Document #	RPP-24544	Revision	1D
Title	DEMONSTRATION BULK VITRIFICATION SYS INDEPENDENT QUALIFIED REGISTERED PROFESSIONAL ENGINEER (IQRPE & RCRA DESIGN REVIEW PACKAGE		
Date	05/11/2006		
Originator	SHUFORD DH	ORG CO	CH2M
Recipient		Recipient Co.	
References	ECN-723118-R5, RPP-24544-R0, RPP-24544-R1, RPP- 24544-R1A, RPP-24544-R1B, RPP-24544-R1C, EDT- 821657, ECN-723118-R0, ECN-723118-R1, ECN- 723118-R3, ECN-723118-R4		
Keywords	SUPPL TREATMENT		
Projects

CALCULATION COVER SHEETCALC. NO.: 145579-C-CA-015 REV: 2 DATE: 26 March 2006CALC. TITLE: OGTS Steel Stack Foundation (Foundation #10) (Total Pages =113)PROJECT NO.: 145579 PROJECT TITLE: Final DBVS DesignDesign Verification Required: Yes NoCalculation Type: Scoping Preliminary FinalSuperseded by Calculation No.: _____ Voided**ORIGINAL AND REVISED CALCULATIONS/ANALYSIS APPROVAL**

CALC. NO.: **145579-C-CA-015** REV: **2** DATE: 26 March 2006
 CALC. TITLE: OGTS Steel Stack Foundation (Foundation #10)
 PROJECT NO.: 145579 PROJECT TITLE: Final DBVS Design

Bulk Vitrification Off-Gas Area Fdns - Plans & Sections

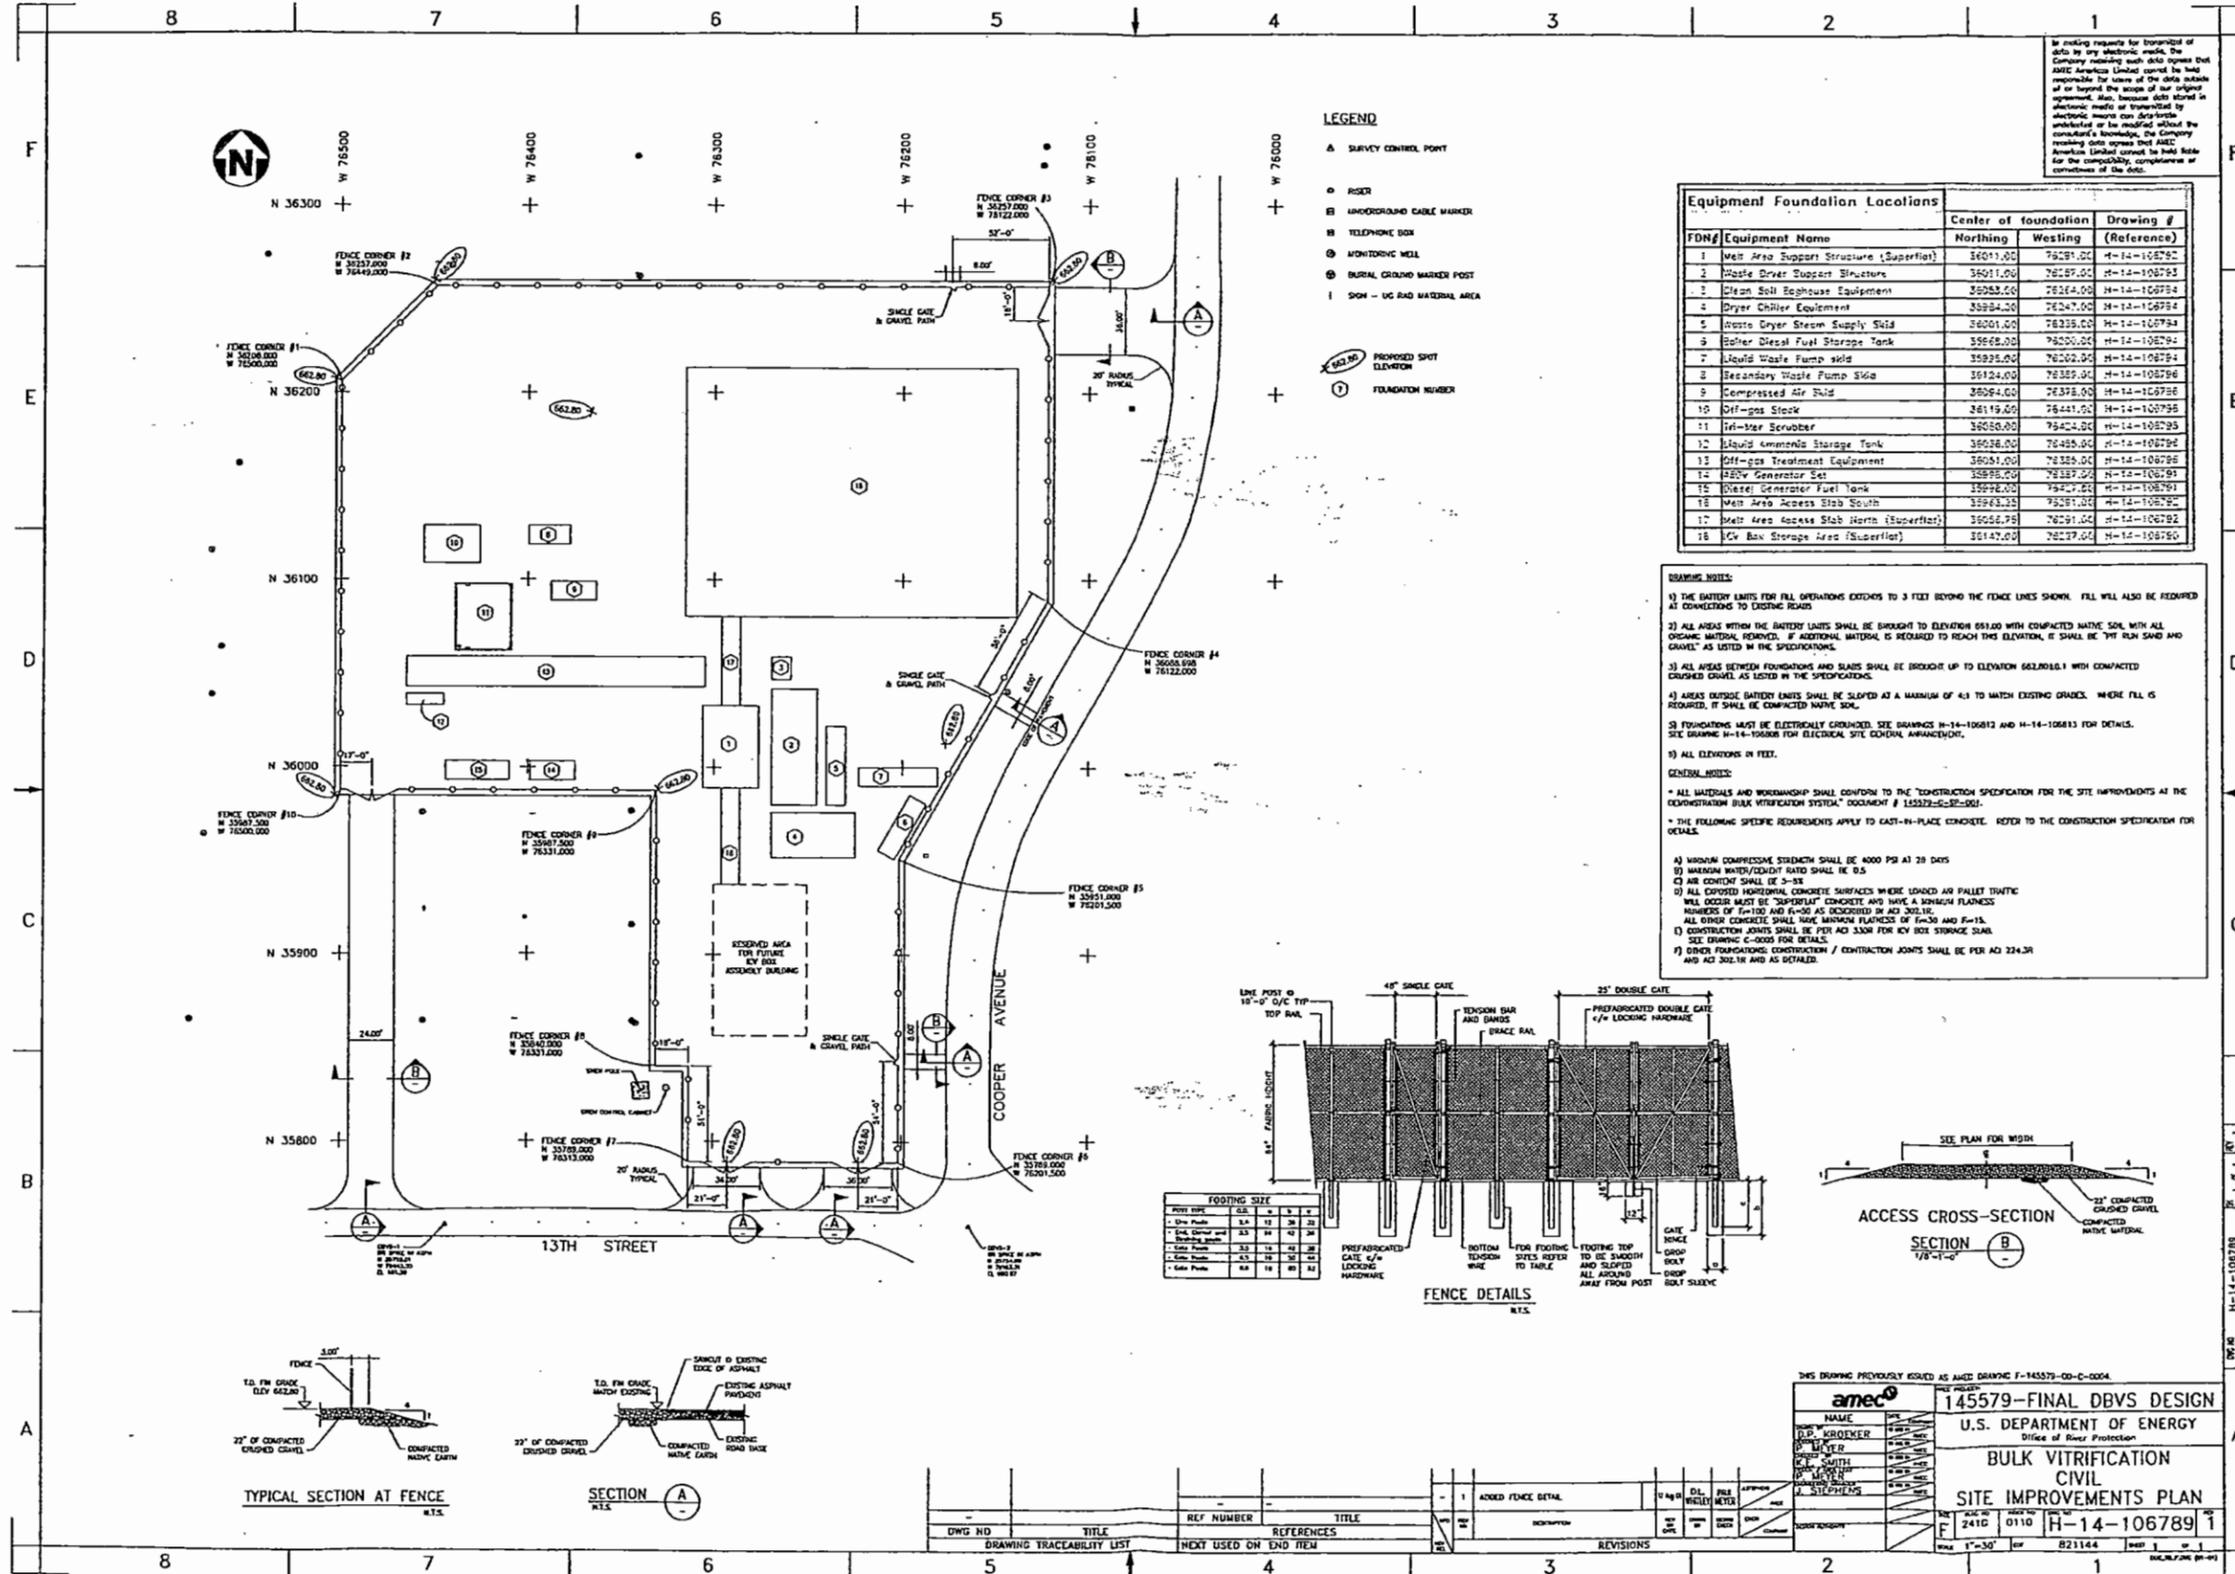
* Note that drawing H-14-106796 Rev 0 gives the off-gas stack foundation dimensions as 30' x 20'. This calculation provides dimensions of 36' x 24'. The off-gas stack foundation drawing must be updated.
